Covering Note - Response to NatureScot Points (a) and (b) – River Moriston SAC

1.1 On 19 January 2026, NatureScot submitted a further updated consultation response in respect of the application for section 36 consent and deemed planning permission for the Glen Earrach Pumped Storage Hydro Scheme (the 'Application'). The NatureScot response related specifically to impacts on the River Moriston Special Area of Conservation ('SAC'). It identified five areas on which NatureScot wished to receive further information listed as items (a) to (e) relating to the SAC.

Appendix A – Responses to Points Raised by NatureScot in its Response of 25 February 2026

02 General Arrangement - Smolt Pass 1
0104 1:250

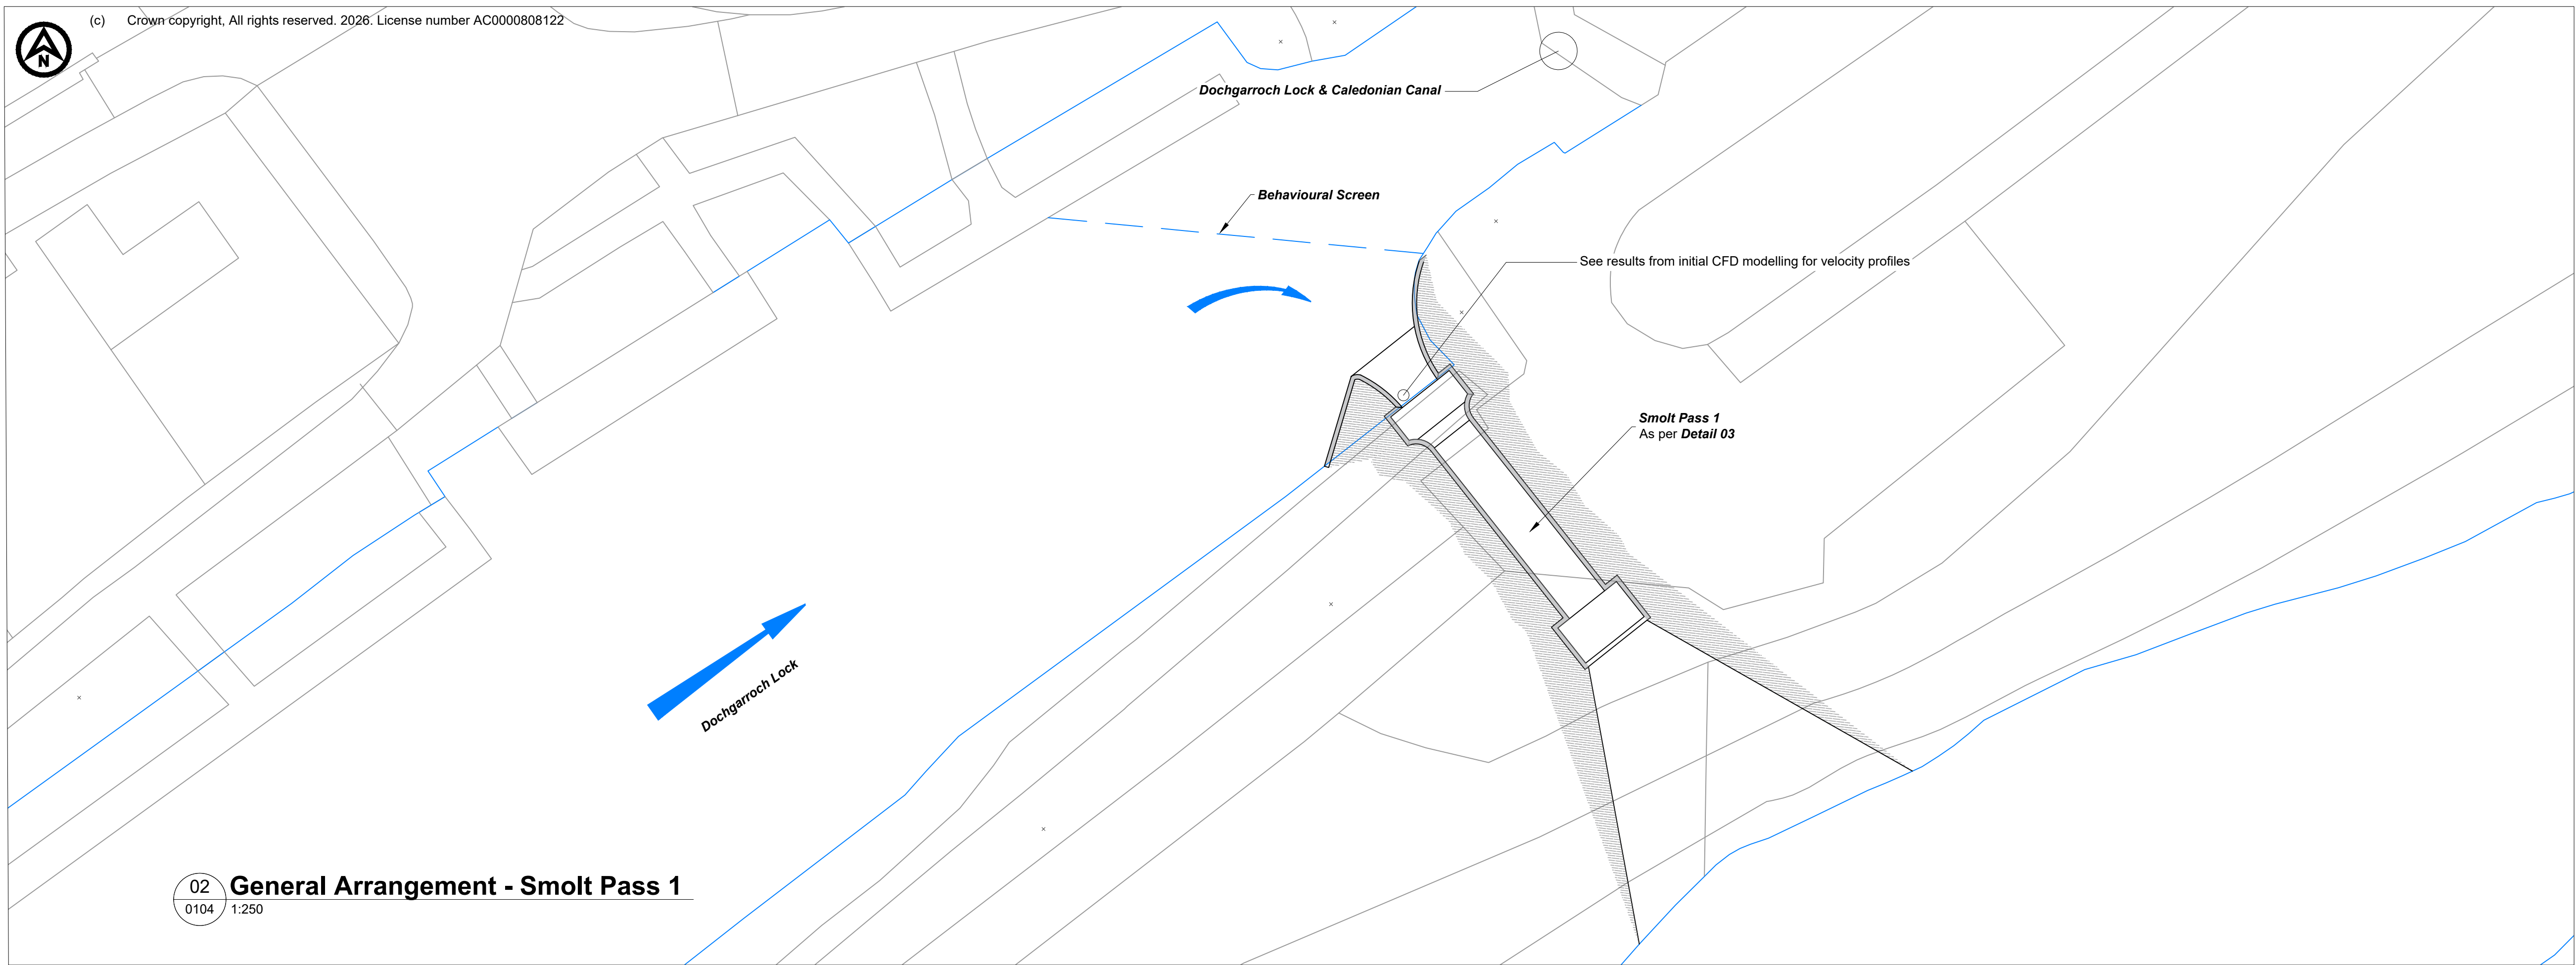
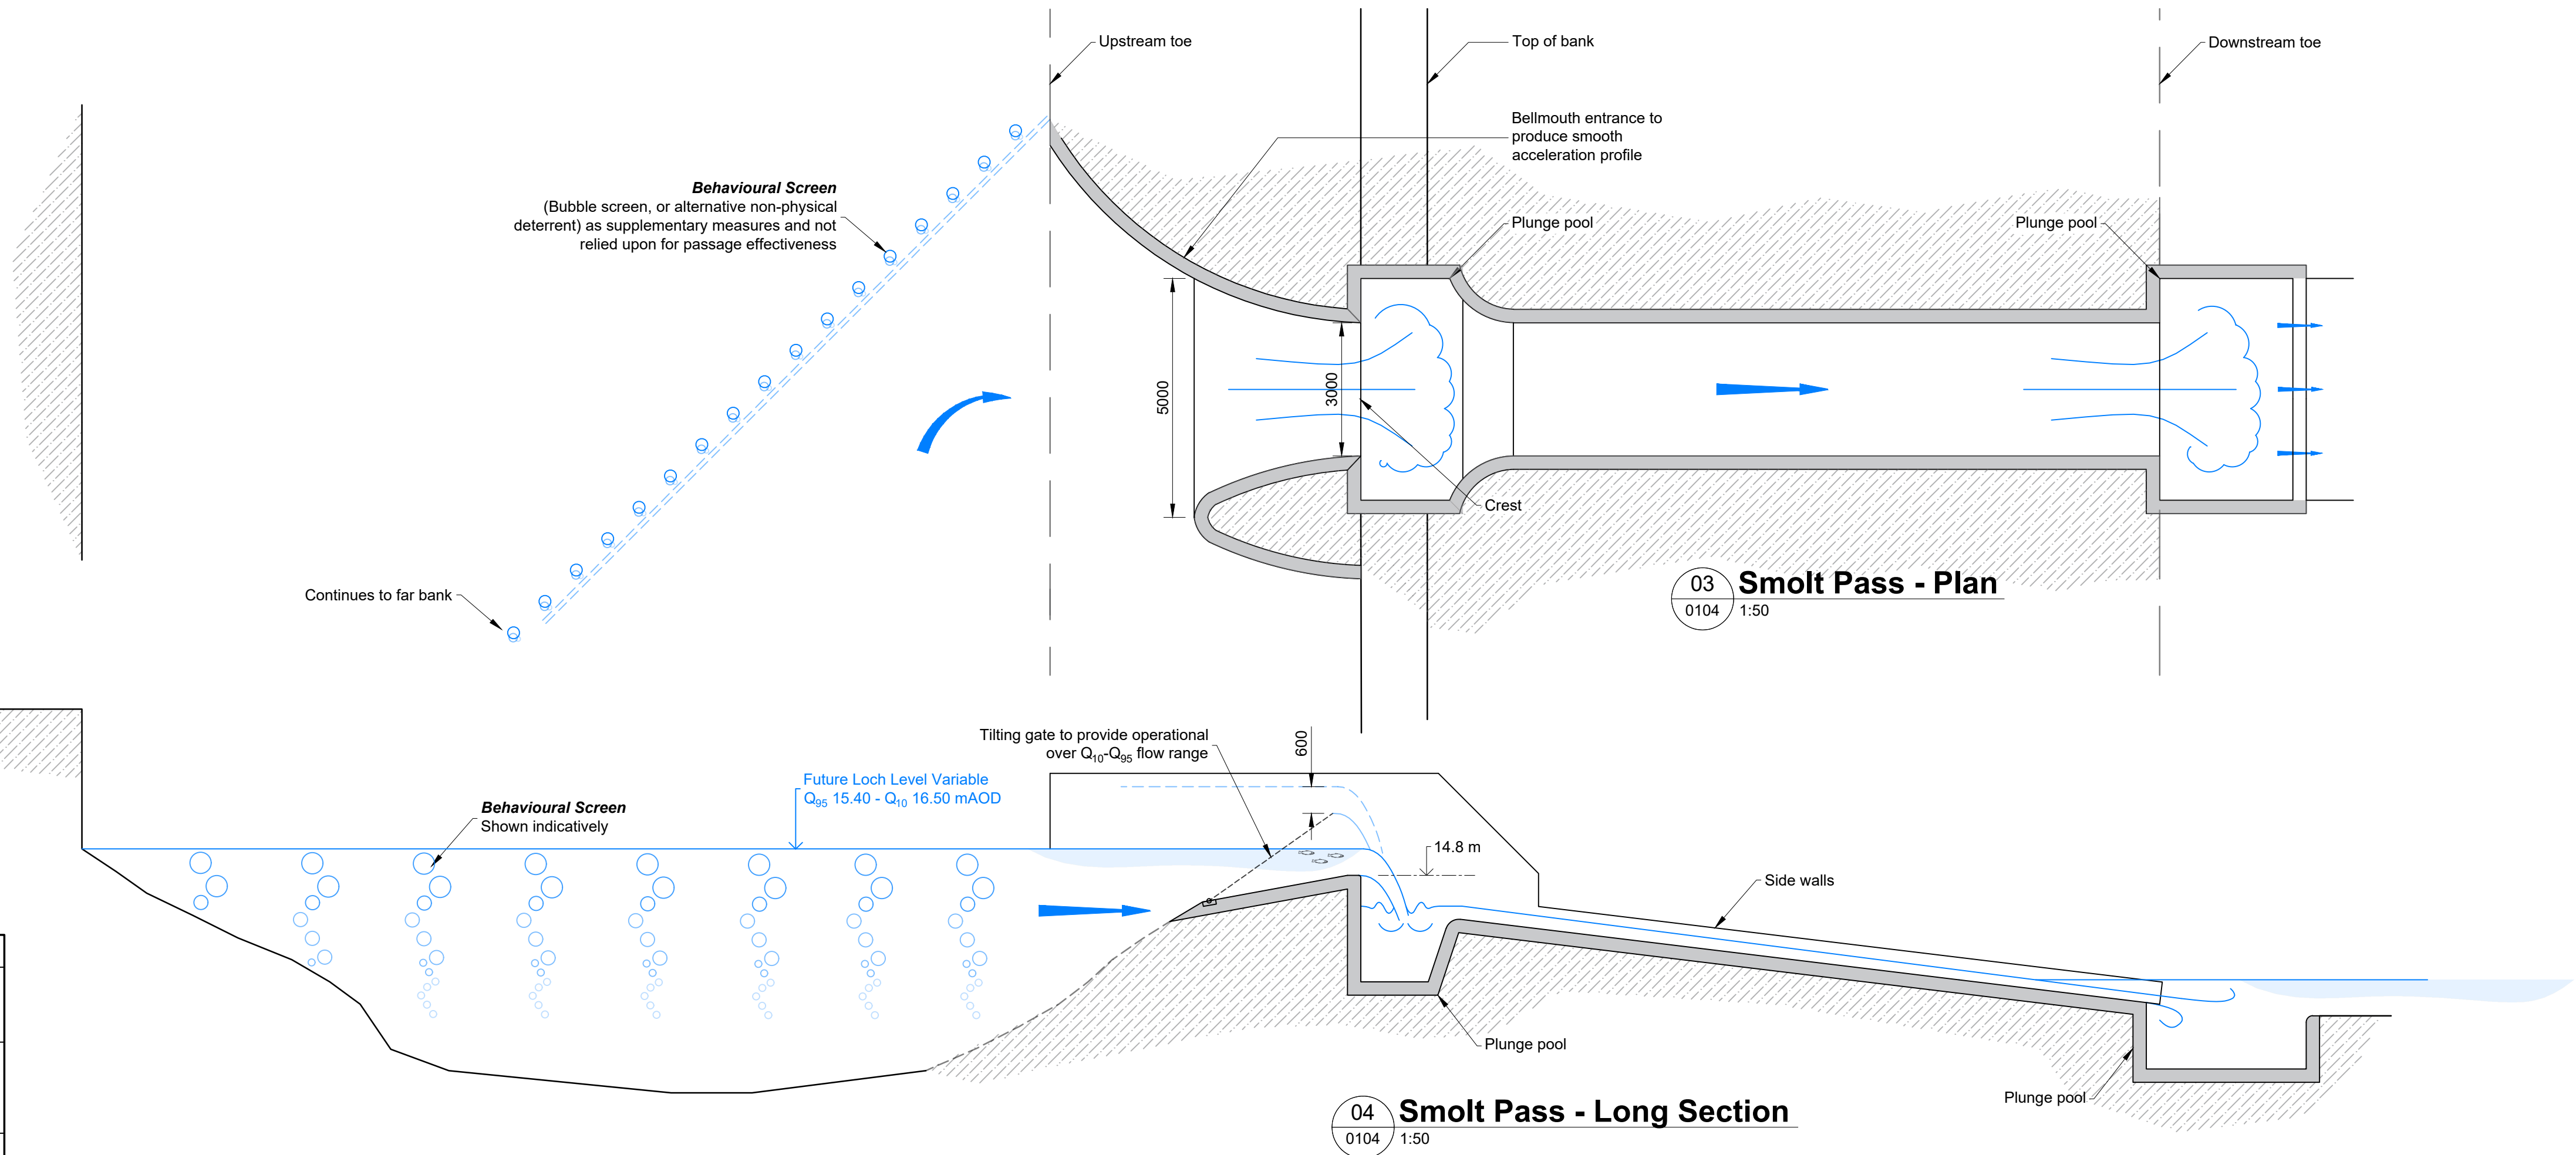
There are no design dimensions given for the three downstream passage routes. The key in the document Location, Site plan and Smolt passage states that: "Full hydraulic design is required at outline design phase to ensure that species specific passage requirements are met.". These have yet to be provided so no assessment of the viability of the proposed options can be made at this time.

*Applicant response: the hydraulic design of these structures has been developed to inform sizing and flow rates of each smolt pass, as can be seen in drawing 0104-3540681-P01 - Smolt Passage, supported by CFD modelling for the most downstream smolt pass as presented in Appendix 2 of the Fishtek *Optioneering Summary*.*
